Independent Technical Review of the Twin Pines Permit Application Hydrologic Modeling

Report Submitted to Fish and Wildlife Service

February 2023

Figure 1. January groundwater heads from GA-EPD's letter to Twin Pines (Kennedy, 2020)

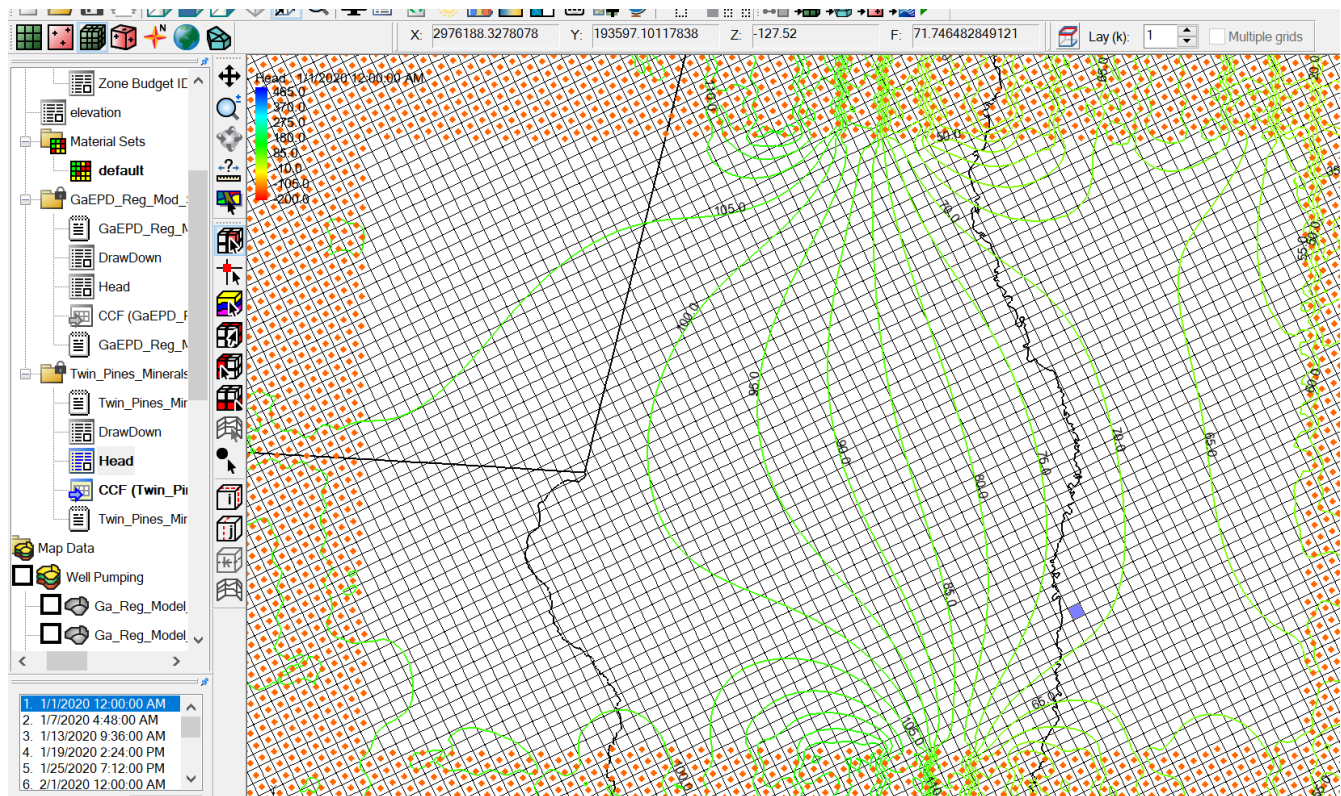
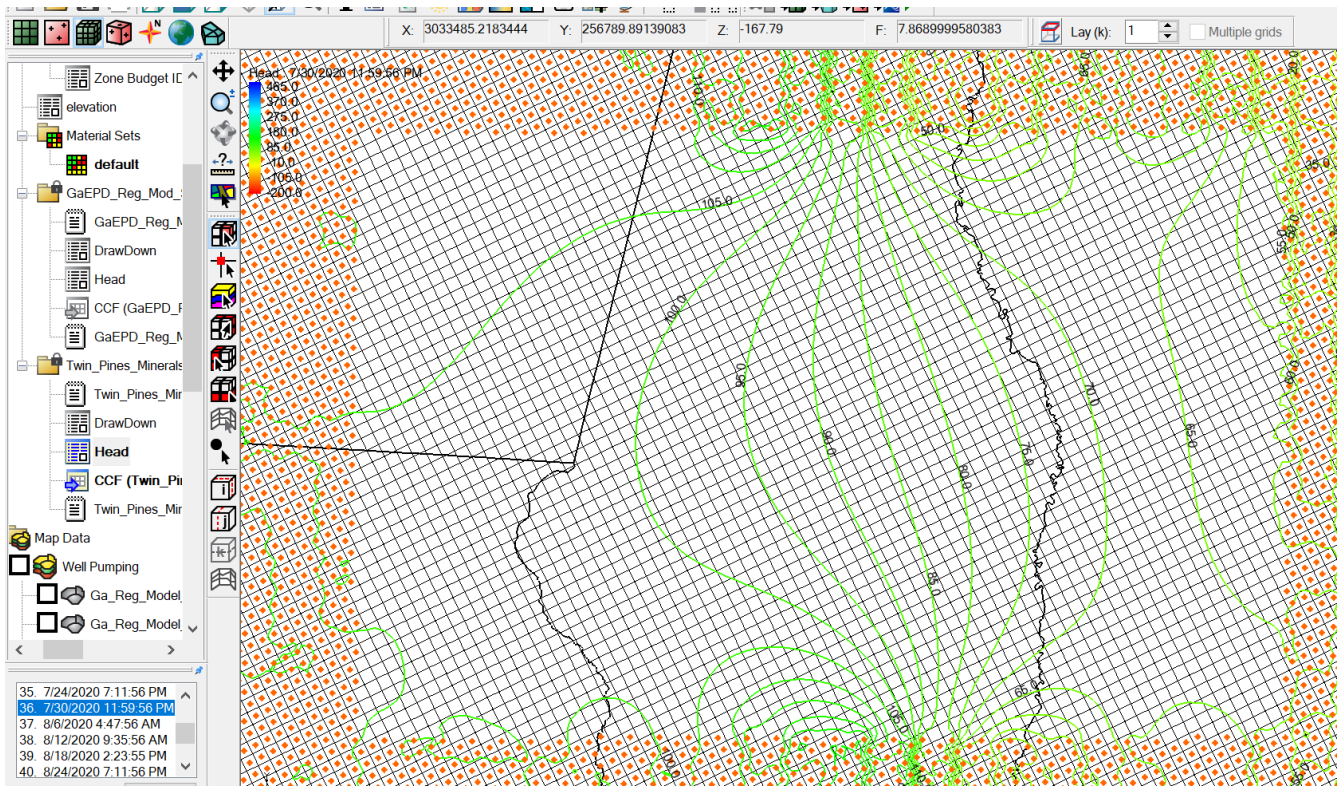
The use of a steady-state model configuration for modeling the effects of mining and re-filling of the pit was allowed by Kennedy (GA-EPD) and justified by using an analysis he completed with a transient model used by the GA-EPD (Kennedy, 2020). In his analysis he set Layer 1 to variable head and compared groundwater stage maps for two dates (6 months apart) that represented high and low recharge periods. In his report he showed two images from this model with dates of January 1st 2020 (Figure 1) and July 1st, 2020 (Figure 2). He concluded that since the groundwater surfaces across the domain were similar on these two dates, a steady-state model *could* be used by TP (Kennedy, 2020).

Kennedy’s transient model only showed groundwater stage in two timesteps (two days) that were six months apart but did not show any temporal variability in stage. Observed data at groundwater wells show 4 feet of variability (Holt R. M., Tanner, Smith, Patton, & Lepchitz, 2019). Kennedy’s plots for January and July are in fact *exactly* the same (see Figure 1 and Figure 2), which also calls into question the sensitivity of the transient model.

Figure 4. Groundwater elevation vs. precipitation for station PZ-01 (Holt R. M., Tanner, Smith, Patton, & Lepchitz, 2019)

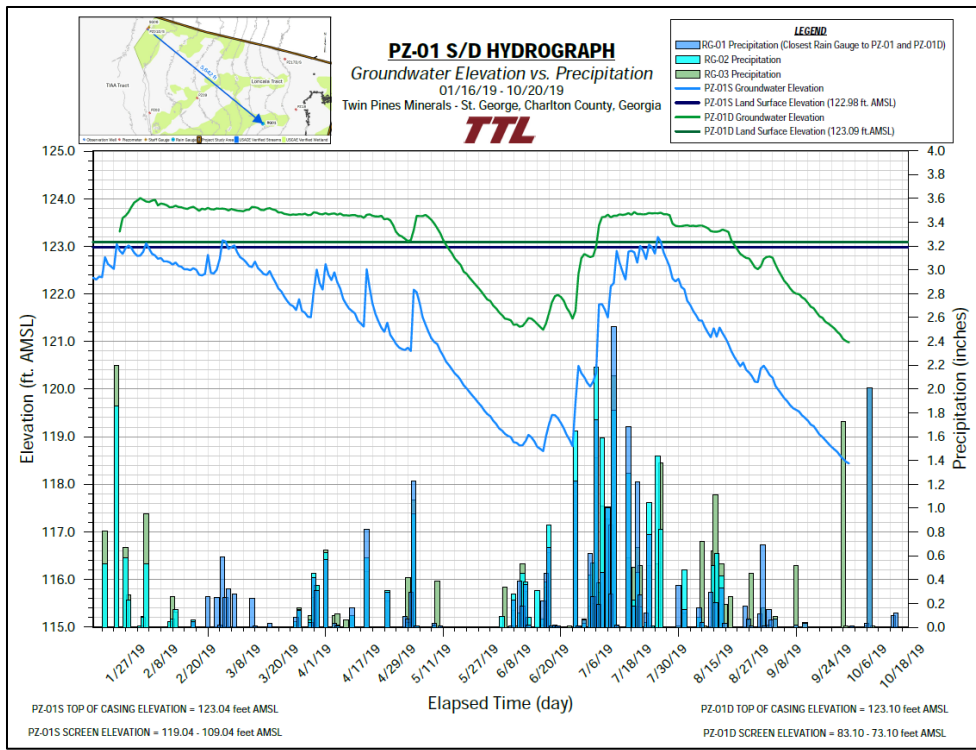
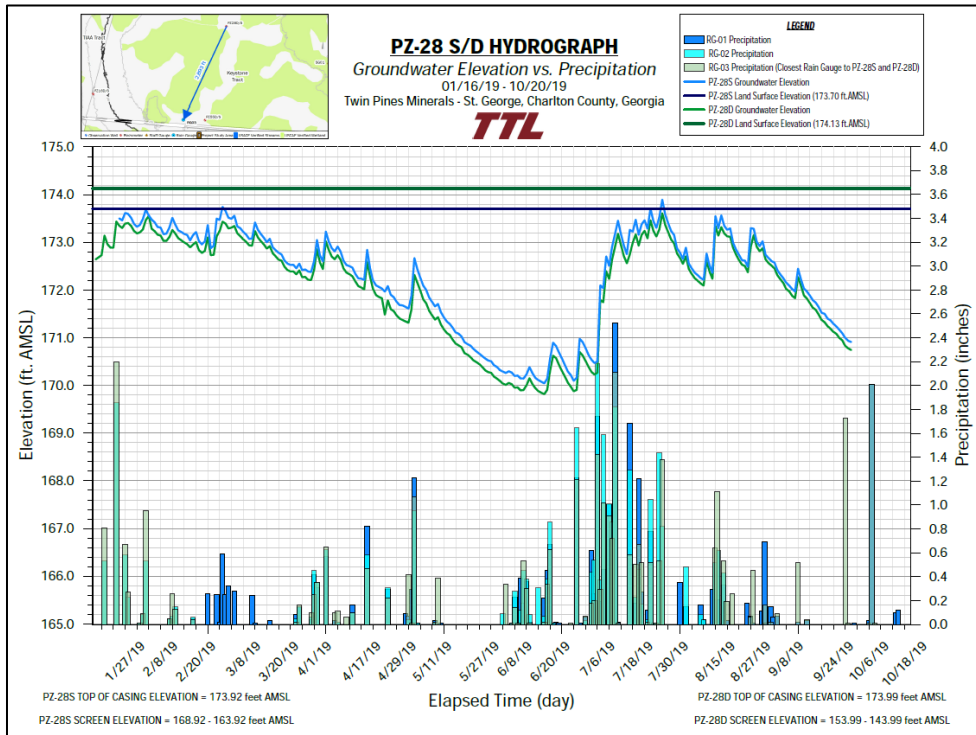
We investigated this result with a review of variability in groundwater levels at stations within the region (Figure 3). As an example, in 2019, groundwater stages measured from groundwater wells varied about 4 feet from minimum to maximum for station PZ-28 within the proposed mining area (Figure 4), and 4 feet for station PZ-01 near ONWR and the northern model boundary (Figure 5).

Figure 7. Stream channels extending between the proposed mine site and ONWR. The model domain does not include the area where the stream channel enters ONWR. Base map is from (Panday, Wyckoff, & Martell, 2021), with shading and red annotations added by the authors of this report.

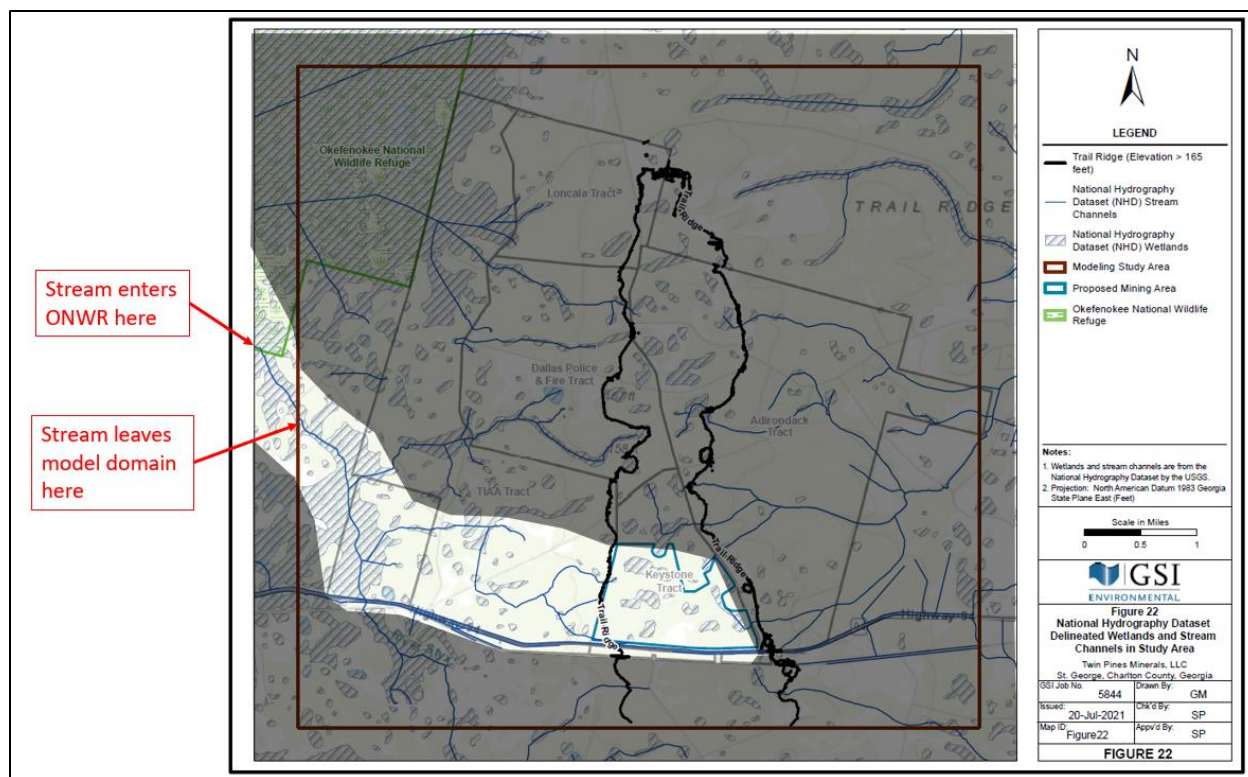
The model domain, however, omits the direct flow path connection between the proposed mine site and its final destination, the ONWR (see Figure 7). Ideally, it would be appropriate to set model boundaries to the natural divides in the watershed, to meaningfully capture all downstream effects of perturbation of the environment.

The model domain is not large enough to accurately assess the impacts on ONWR. Also, averaging in results from watersheds that do *not* connect the mine site and ONWR obfuscates the true impacts from mining on the refuge.

Figure 8. Model grid, showing boundary conditions. Drain cells are in yellow, and constant head boundary cells are in pink (Panday, Wyckoff, & Martell, 2021)

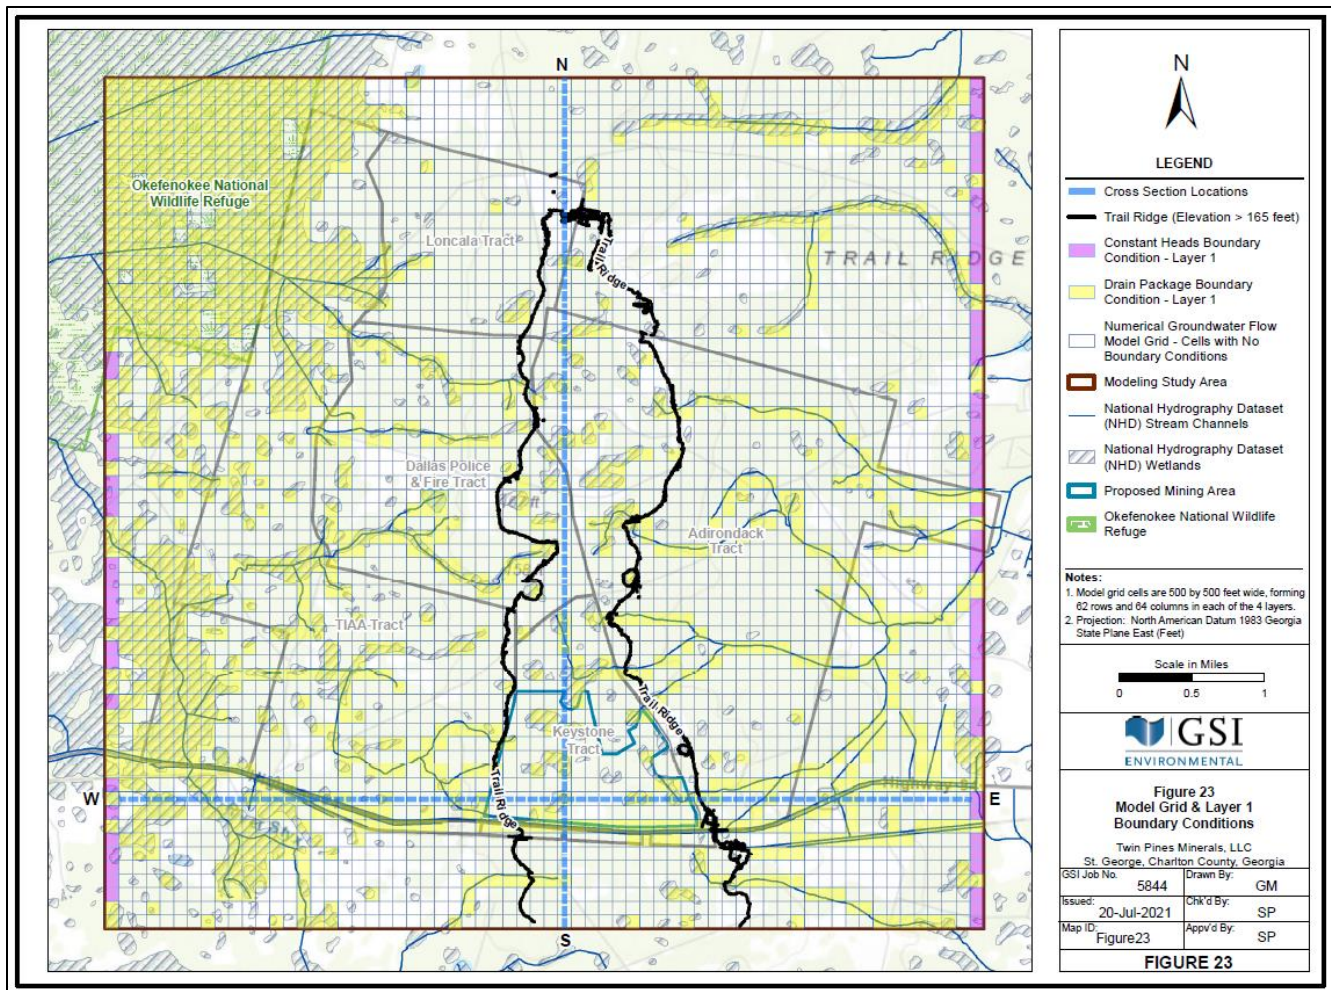
The drain elevations in the soil disturbance and dewatering models were set to the streambed elevation or the elevation of the wetland, according to Panday (Panday, Wyckoff, & Martell, 2021), for all of the drain cells in the model (shown in yellow in Figure 8).

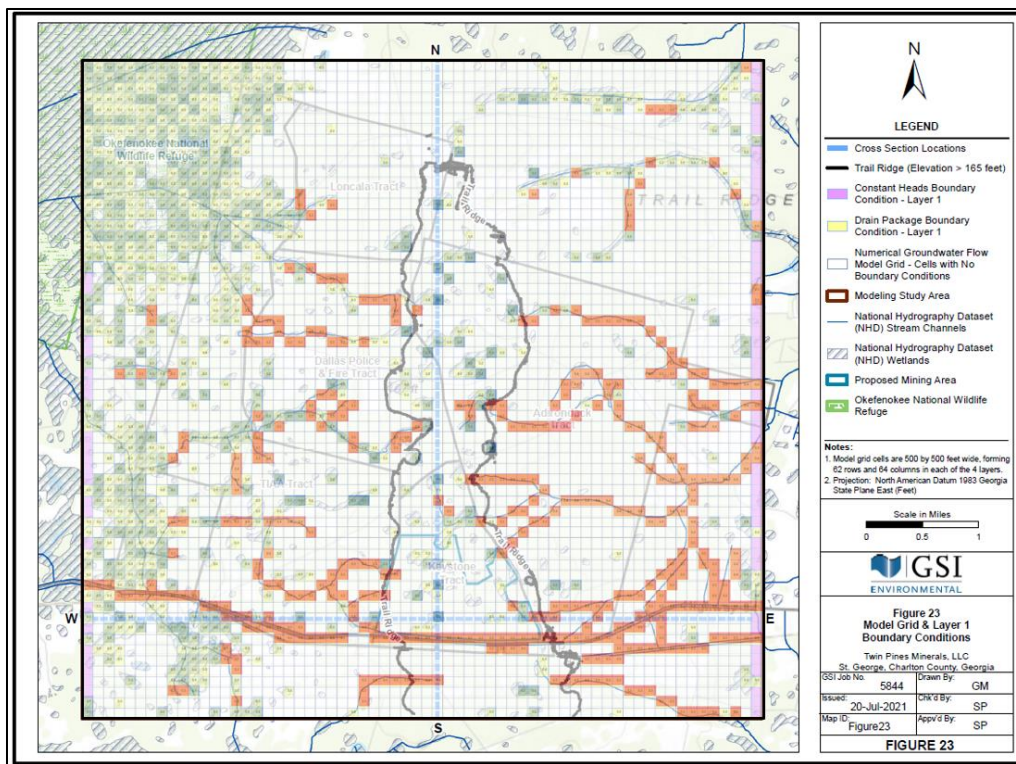
In the models provided by GA-EPD to NPS, however, many of the drain cells were found to be 0.5 feet *below* the land surface elevation (shown in red in Figure 9). For example, in the “v01a_TPM_GwFlow_Cal_OF_NWR_Bal model”, the land surface elevation of the cell in row 52 and column 26 (from the DIS file) is 142.39 ft., and the drain elevation in the same cell (from the DRN file) is 141.89 ft., a difference of 0.5 ft. This was found to be true for several models used in the TP analysis. The reasons for this were not explained in the report. Setting cell elevations shown in red in Figure 9 half a foot lower than land surface elevation can significantly affect the water flow dynamics in the model, especially in wetlands and streams. These discrepancies in cell elevations need to be addressed before model results can be considered reliable.

Figure 10. Rain gauge location map. Red text and arrows added by the authors of this report (Holt R. , Tanner, Smith, Patton, & Lepchitz, 2019)

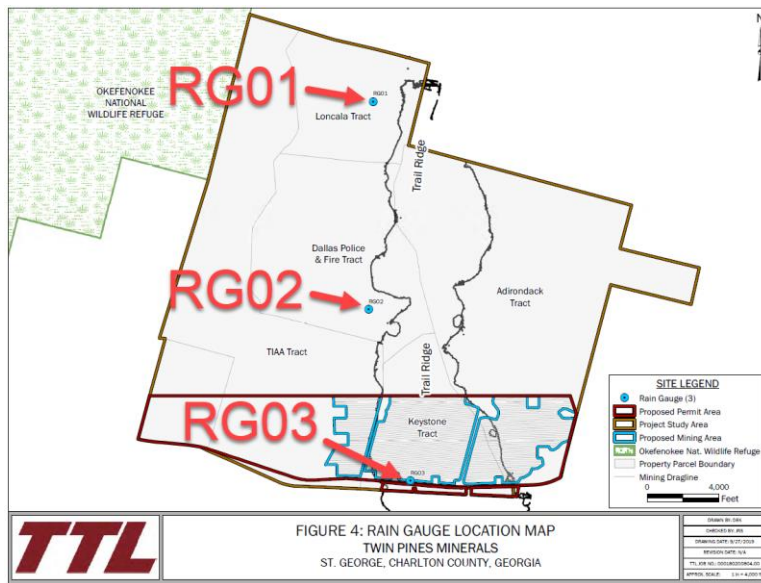
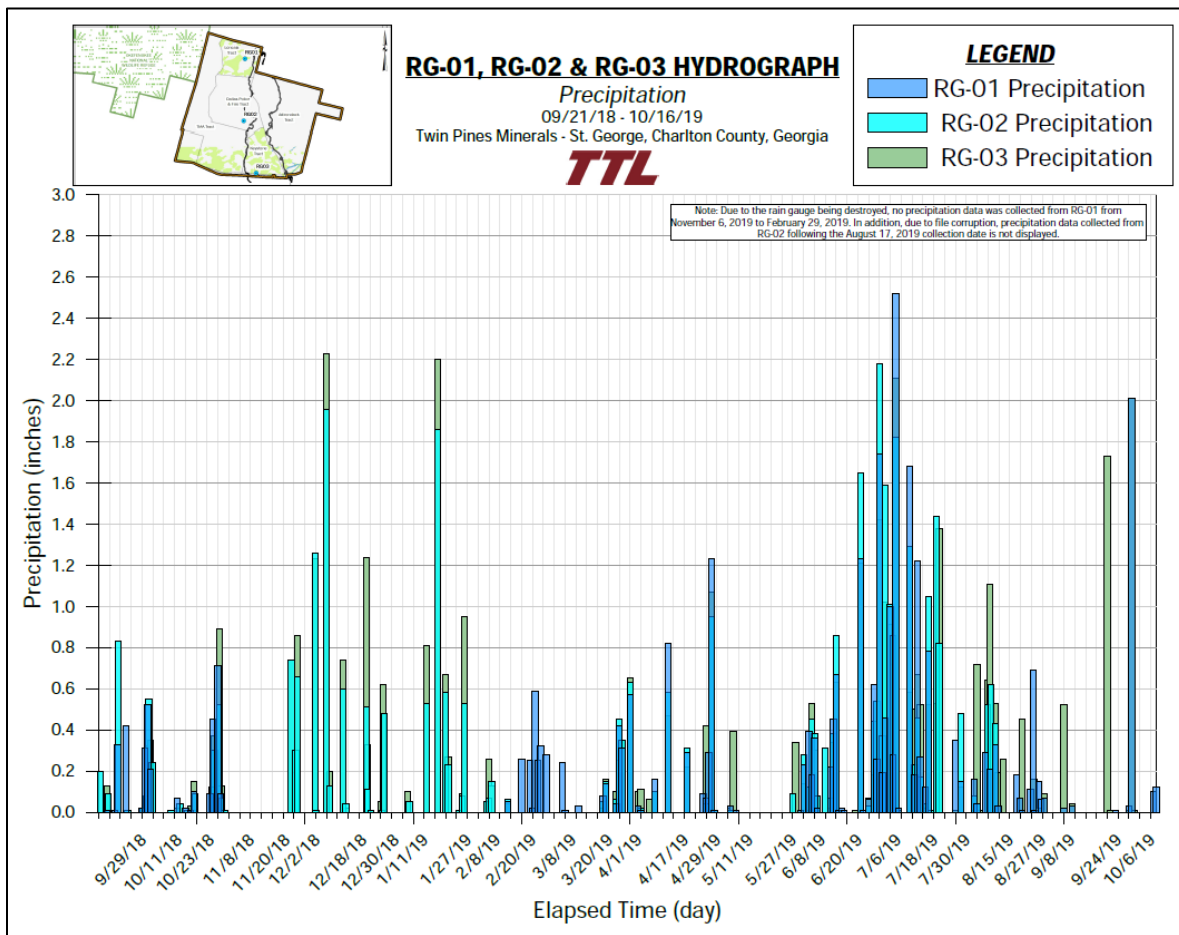
In the soil disturbance and dewatering models, a constant recharge rate of 4.13 inches/year (difference between precipitation and evapotranspiration) was applied to all cells within the model domain (Panday, Wyckoff, & Martell, 2021). The three rainfall stations within the model domain (Figure 10) clearly show that there is significant variability in precipitation in both time and space (Figure 11). Also, there is a large variability in evapotranspiration in time and space due to differences in land-use, hydrologic conditions and seasonal and interannual variability in temperature. Figure 12 shows the location of the station at Folkston, GA. This station illustrates how rainfall and evaporation measured at the site change through the months of the year, and how the *differences between* rainfall and evaporation measured at this site also change through the months (Figure 13). Without spatio-temporal variability representation of recharge rates in the model, it is difficult to evaluate the impacts of mining on ONWR, particularly during the dry periods. Since recharge is the single source of water for the model and has a strong seasonal variability, simulations of the hydrology of this area need to accurately characterize spatiotemporal variations.

Figure 13. Precipitation and evaporation at Folkston station (Holt R. , Tanner, Smith, Patton, & Lepchitz, 2019)

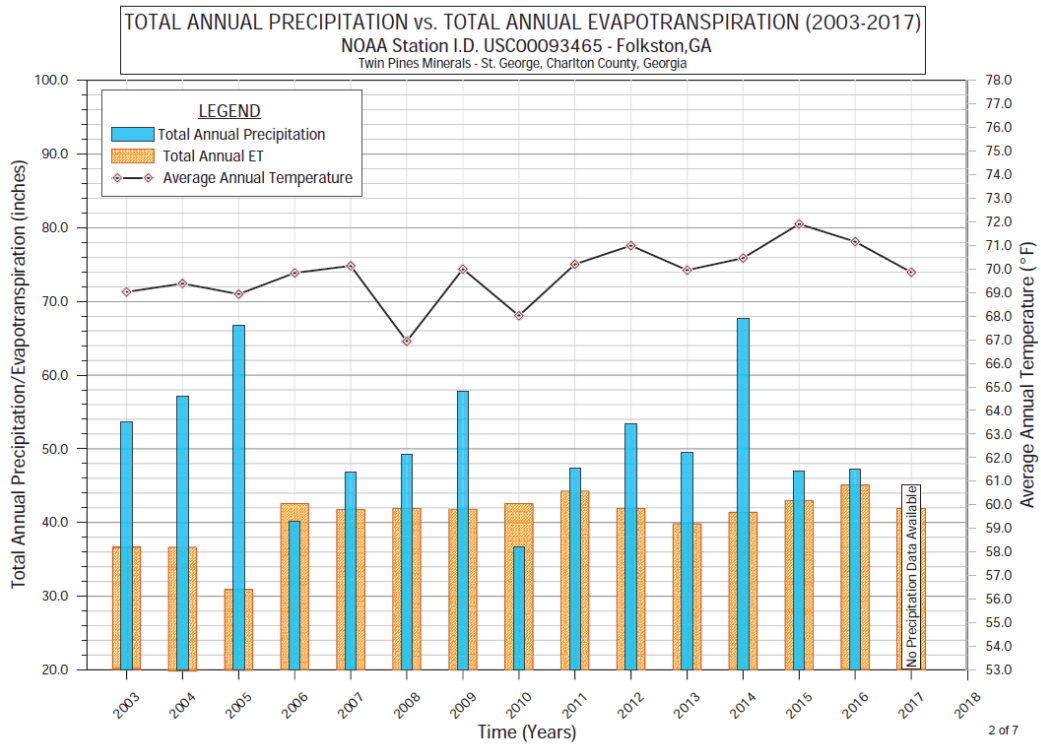
In addition, the average of 10-month groundwater levels used to calibrate the model is not sufficient to capture the seasonal and interannual variability (Figure 16). Datasets in nearby sites show a significant interannual variability in precipitation, evaporation, and recharge (see Figure 13). The response of this variability on groundwater levels is not captured with average values and steady-state simulations.
